PROPOSED HARVEY - KWINANA 330kV
TRANSMISSION LINE

Report and Recommendations
of the
Environmental Protection Authority

Environmental Protection Authority
Perth, Western Australia
Bulletin 338 July 1988

Figure 1 Proposed and existing 330kV transmission line

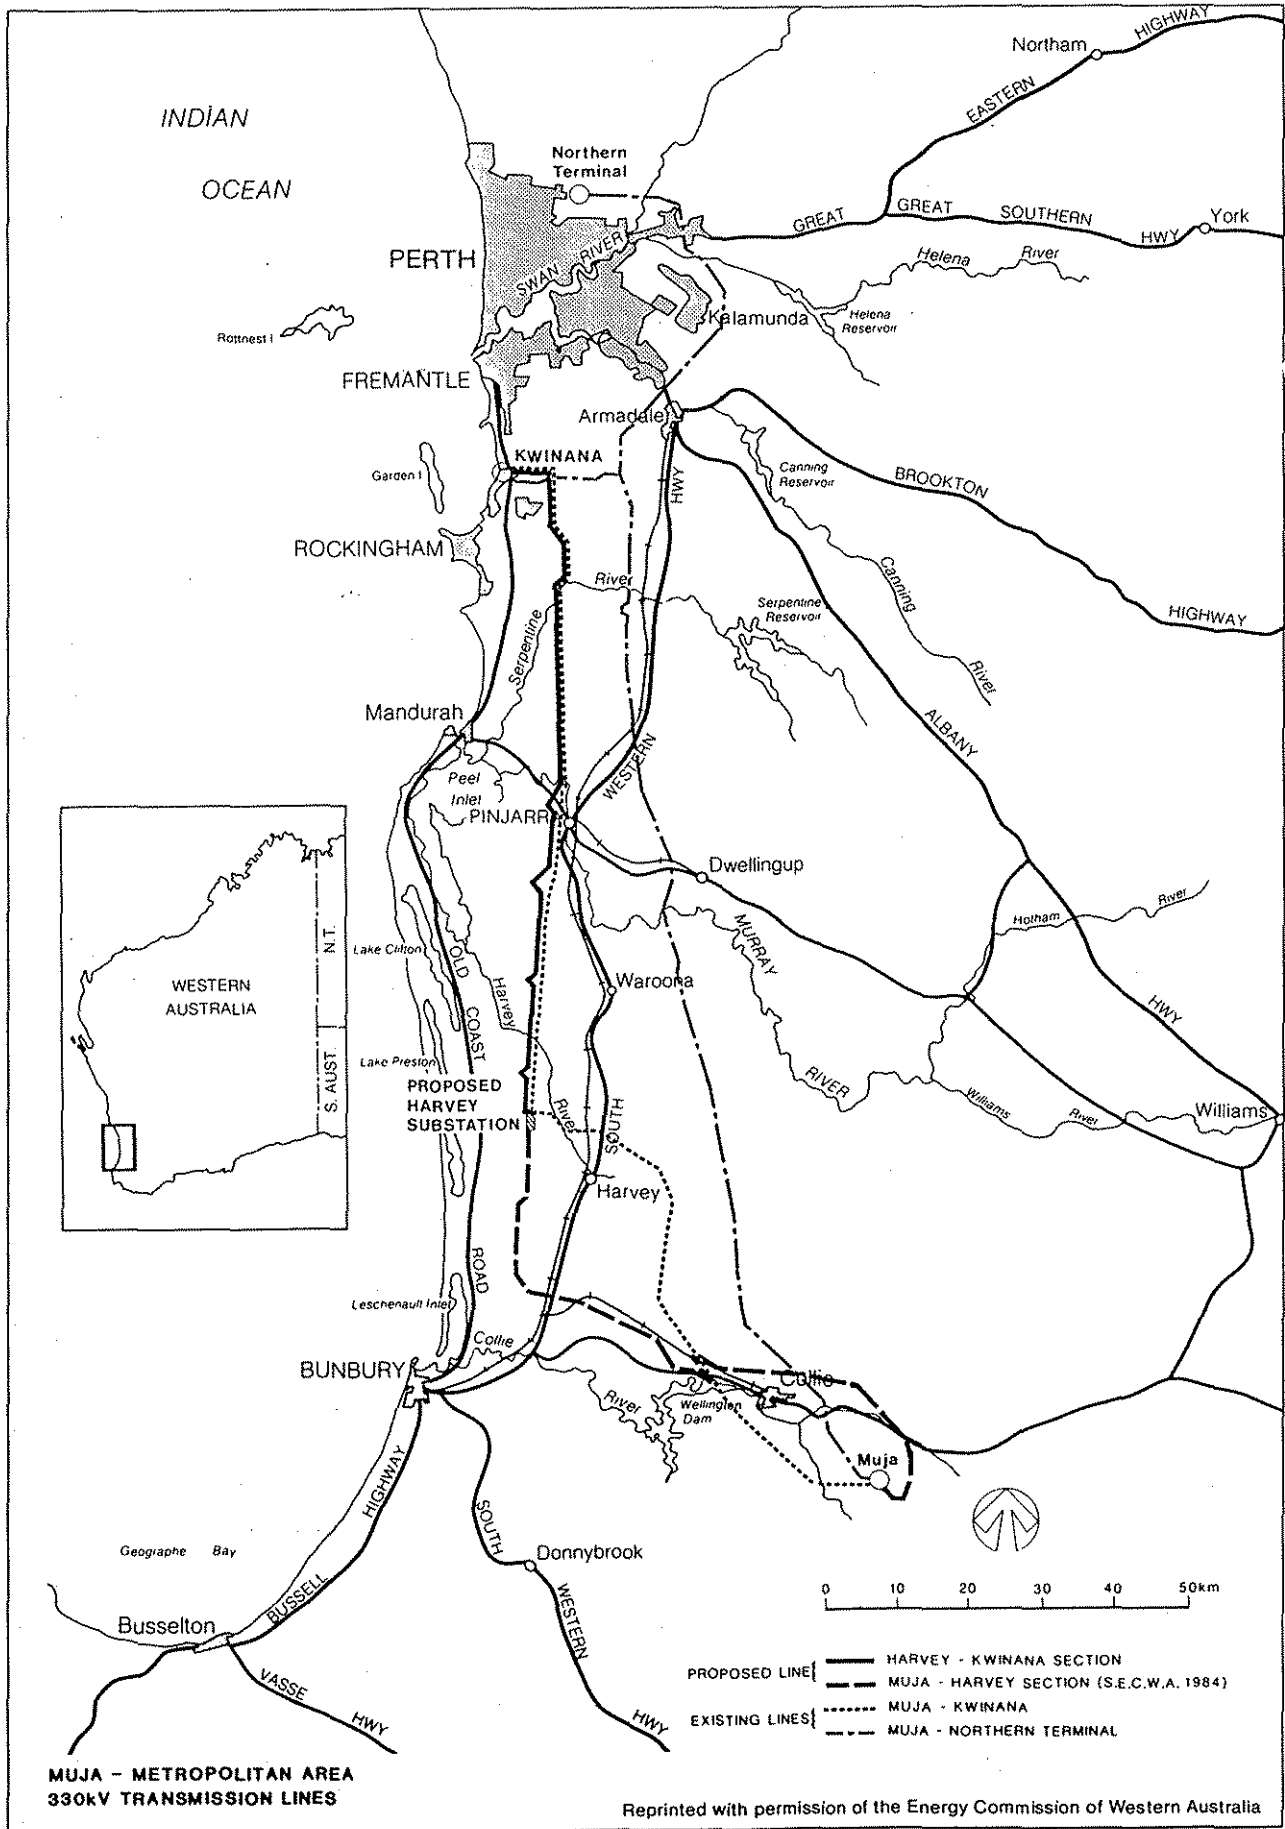
The proposed route for the transmission line is outlined in Figure 1.

The transmission line corridor should follow the deviation around the native vegetation at Murray Locations 323 and 688, between Buller and Coronation Roads, Shire of Waroona. The subject area is within the Peel- Harvey Catchment Area and any clearing of vegetation in this area could contribute to the problems already existing in the Peel-Harvey Estuary. Further clearing in this area is therefore discouraged by the Authority. The proposed deviation in this area would therefore be preferred as it does not lead to clearing.

The Environmental Protection Authority recommends that the proposed transmission line should follow the deviation around the native vegetation at Murray Locations 323 and 688, between Buller and Coronation Roads, Shire of Waroona.

TYPICAL CLEARING PROFILE FOR 60m EASEMENT FOR 330kV SINGLE CIRCUIT LINE

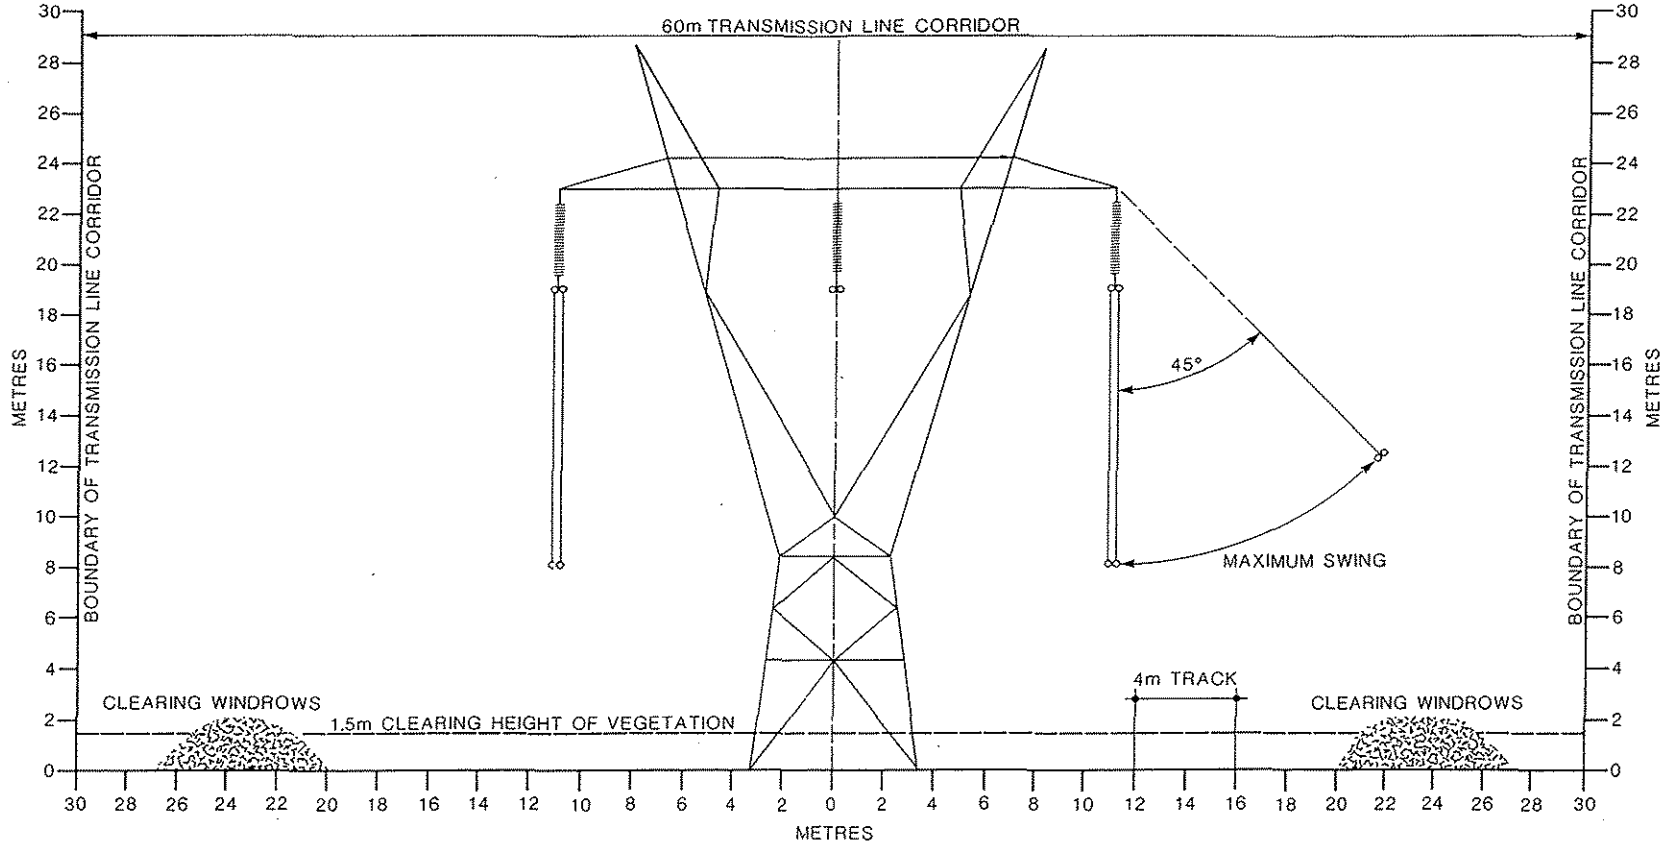
- (iv) Compensation will be negotiated where farmers suffer loss of production brought about by establishment of an easement.
- (v) Periodic line inspections will be undertaken in order to maintain the desired window-type "clearing profile" of the easement. (This is depicted on Figure B1 in Appendix B)
